**Head Studs for DB4, DB5, DB6 & DBS
(Re-designed)**

At JMB Services we pride ourselves on pursuing correct engineering processes, which is a comparative reason for re-designing the 6 cylinder head stud, mainly to locate and lock at the stud bottom in line with the later V8 stud.

Figure 1
L1:
 Measure a dummy bolt for overall length,
L2:
 Screw dome nut fully on and measure the bolt left protruding from the nut.
 $L1 \text{ minus } L2 = L3$
 total length of nut thread.

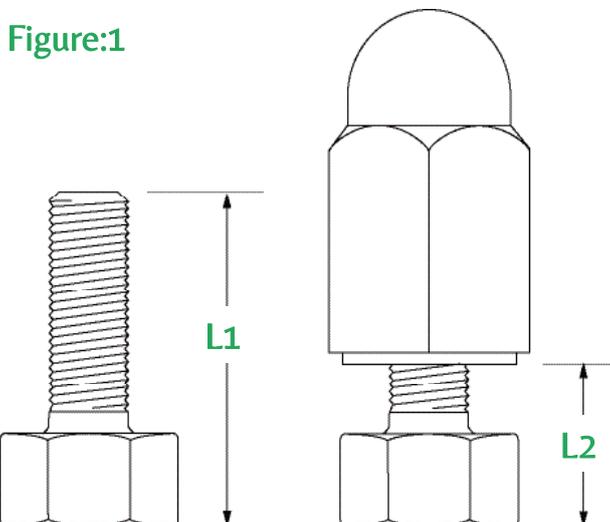
Bearing in mind the infinite variations of head thickness, due to re-machining the cylinder head face, the head nut faces, the use of different thickness washers, we would suggest a dummy assembly of one stud. This would determine the length of thread above the washer, which should be approximately 1/16" less than the depth of thread available in a dome nut, as in Figures 1 & 2.

After completing this simple but important check, you will probably find the block needs deepening, this is where our special tool will drill each hole to the same depth, allowing each stud to protrude the same amount. When drilling to depth, L5 in Figure 2 should be constant throughout all stud holes.

Figure 2
 $L4$ must be 1/16" less than $L3$ in Figure 1 and $L5$ constant
